*Preliminary Consultation*  
**MONTGOMERY COUNTY HISTORIC PRESERVATION COMMISSION**  
**STAFF REPORT**

<b>Address:</b>	7314 Maple Avenue, Takoma Park	<b>Meeting Date:</b>	9/3/2025
<b>Resource:</b>	Contributing Resource Takoma Park Historic District	<b>Report Date:</b>	8/27/2025
<b>Applicant:</b>	Eric Maier and Krisztina Petz (Eric Hurtt, Architect)	<b>Public Notice:</b>	8/20/2025
<b>Review:</b>	Preliminary Consultation	<b>Tax Credit:</b>	No
<b>Permit No.:</b>	1129183	<b>Staff:</b>	Laura DiPasquale
<b>Proposal:</b>	Construction of new addition and retroactive tree removal

**Figure 11: Proposed front elevation.** Staff notes this view does not show the entire elevation of the proposed addition.

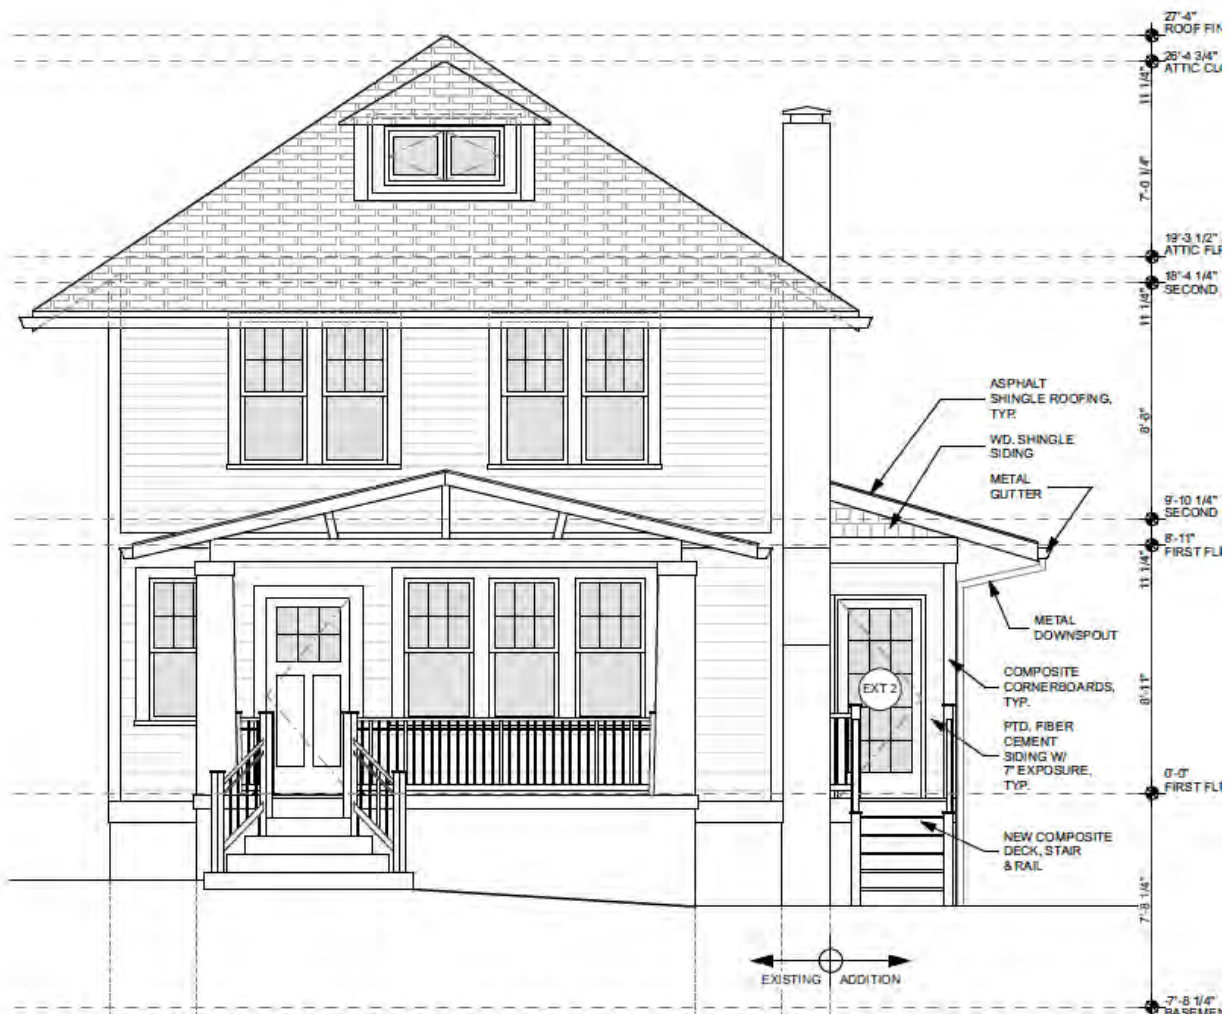
Staff finds that the proposed addition meets most but not all of the recommendations for appropriate additions laid out in the *Rehabilitation Guidelines*. The proposed addition would be located on a secondary elevation and at one-story, would be limited in size and scale in relationship to the historic building. Attaching primarily to the non-historic rear addition constructed in 2015, the proposed addition results in the least possible loss of historic materials, and only obscures a small portion of the side wall of the historic main block. Generally, staff finds that the design of the proposed addition is compatible with the historic building in terms of height, scale, massing, materials, fenestration alignment and rhythm, and relationships of solids to voids. Staff finds that the proposed 7-inch exposure Hardie plank siding, simulated-divided-light clad-wood Marvin windows, and asphalt shingle roof are compatible with the historic structure and surrounding streetscape, as well as the HPC's 2015 approval for siding installation on the main block and new addition, and are consistent with the Guidelines and Chapter 24A-8(b)(2). Staff notes that the proposed composite deck, stair, and railing material is not specified, but should comply with *Policy 24-01*.

Staff does find, however, that the proposed eave overhang is out of scale with the proposed addition and should be reduced. Staff finds that the addition should read as secondary to the main block and not try to

replicate the overhanging eave depth of the main block, which has a different pitch and massing, and should be differentiated from the old, per *Standard 9*.

The larger question for the HPC is regarding the appropriateness of the addition projecting beyond the wall plane of the historic house and eliminating the recess of the 2015 addition at the first-floor. Staff finds that on the one hand, whereas a two-story addition projecting into the side yard would likely read as overwhelming to the historic building, the smaller scale of the one-story projection still reads as subordinate to the historic building. On the other hand, the proposed addition eliminates the small 6-inch recess between the main block and 2015 addition at the first-floor and the purposeful change in wall planes between the old and new. The *Rehabilitation Guidelines* recommend that additions incorporate simple, recessed, small-scale hyphens or connections to physically and visually separate the addition from the historic building, and to distinguish the addition from the original building by setting it back from the wall plane of the historic building. Staff finds that, should the HPC determine that the projection of the one-story addition beyond the side wall plane is appropriate, the addition be shifted back behind the return of the historic main block so that it does not intersect with the side wall plane of the historic house and the full height of the existing trim board between the historic main block and addition remains visible.

**Figure 12: Approved (but not constructed) mudroom addition at 7221 Cedar Avenue, Takoma Park, 1999.**

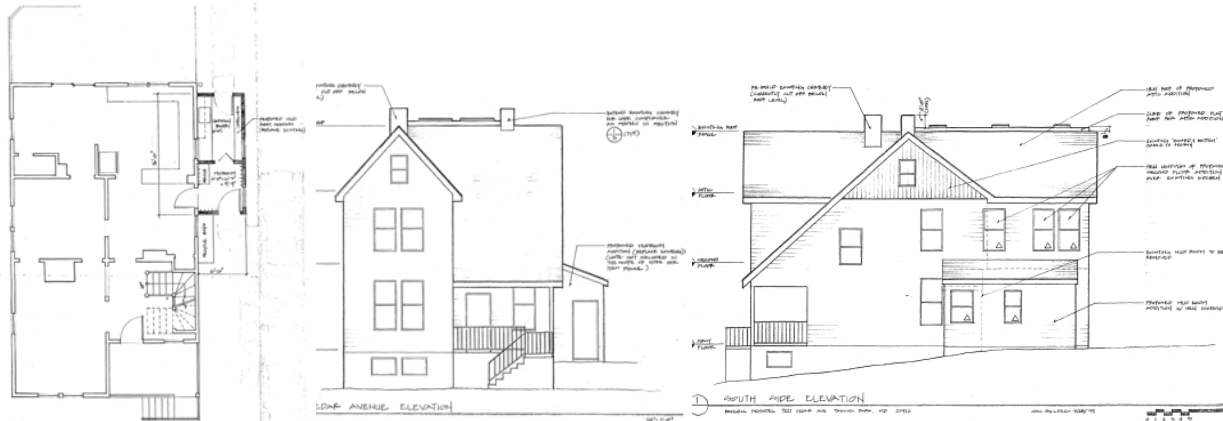
Staff finds that the construction of a one-story projecting side addition is not completely aberrant to the HPC's previous approvals, having found evidence of at least two previous HPC approval for construction of side additions on Contributing resources in the Takoma Park Historic District. In 1999, the HPC approved a small 6-foot wide by 16-foot long mudroom addition at 7221 Cedar, which was not ultimately constructed.<sup>2</sup> The HPC also approved a side addition at 7221 Spruce Avenue, a Contributing resource with significant site constraints, in 1996.<sup>3</sup>

1  
A201  
PROPOSED REAR ELEVATION  
SCALE: 1/4" = 1'-0"

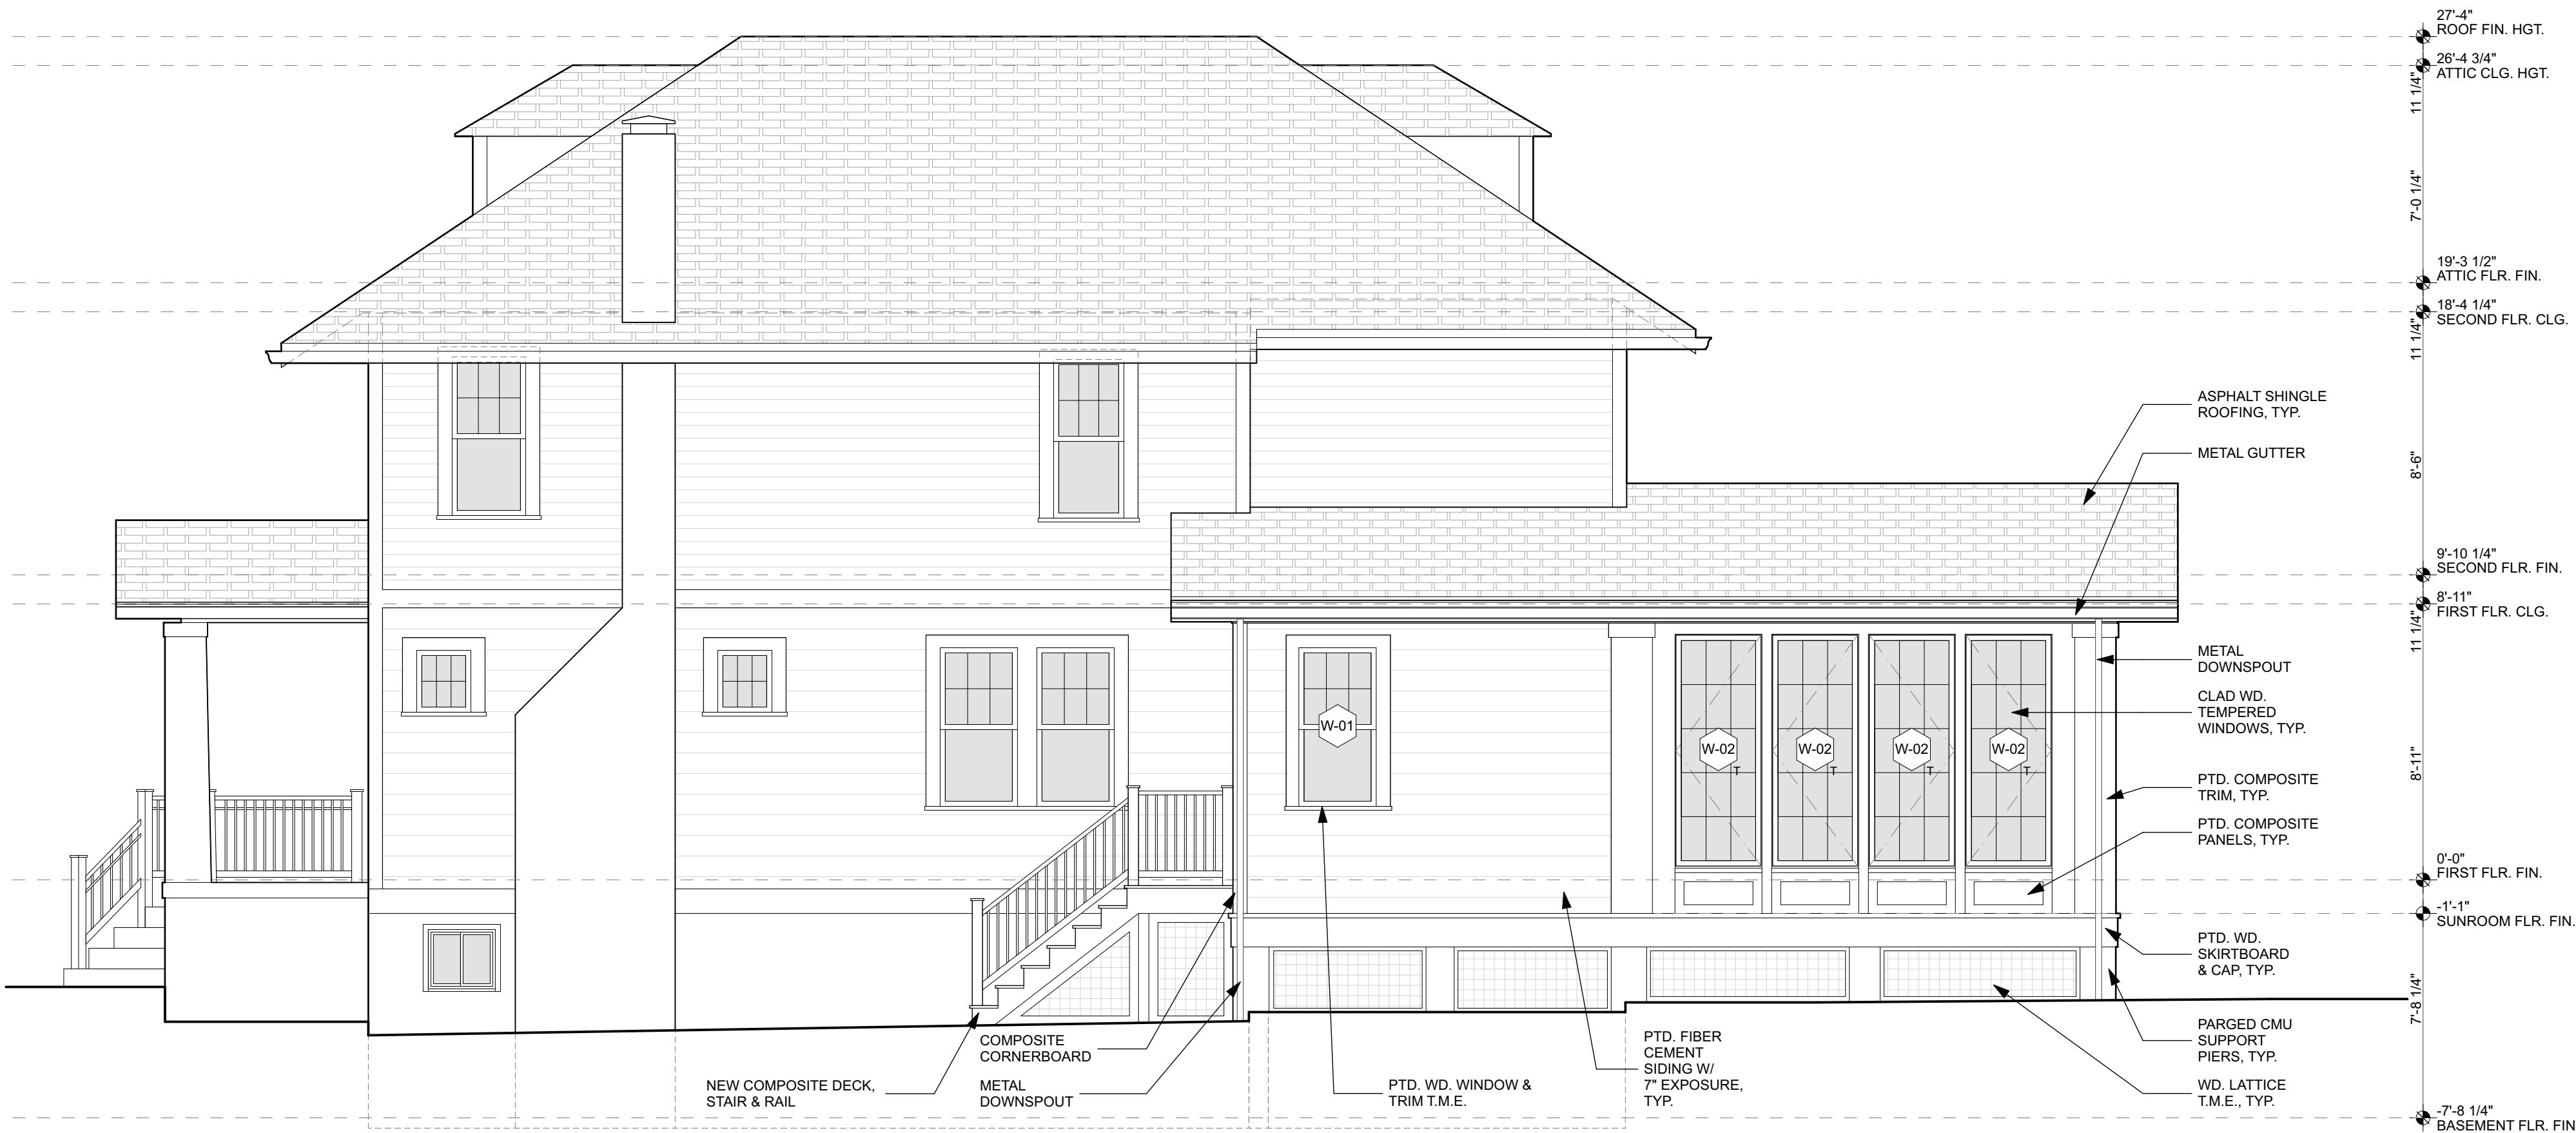
- Existing conditions elevation drawings;
- A full elevation detail of the proposed addition unobscured by the existing building chimney;
- Complete materials specifications, including of the proposed composite porch decking, stair and railings.
- A tree survey showing the location of existing trees on the property and in proximity to the property line, plus the location of a new oak tree to be planted to replace the tree removed without a HAWP.
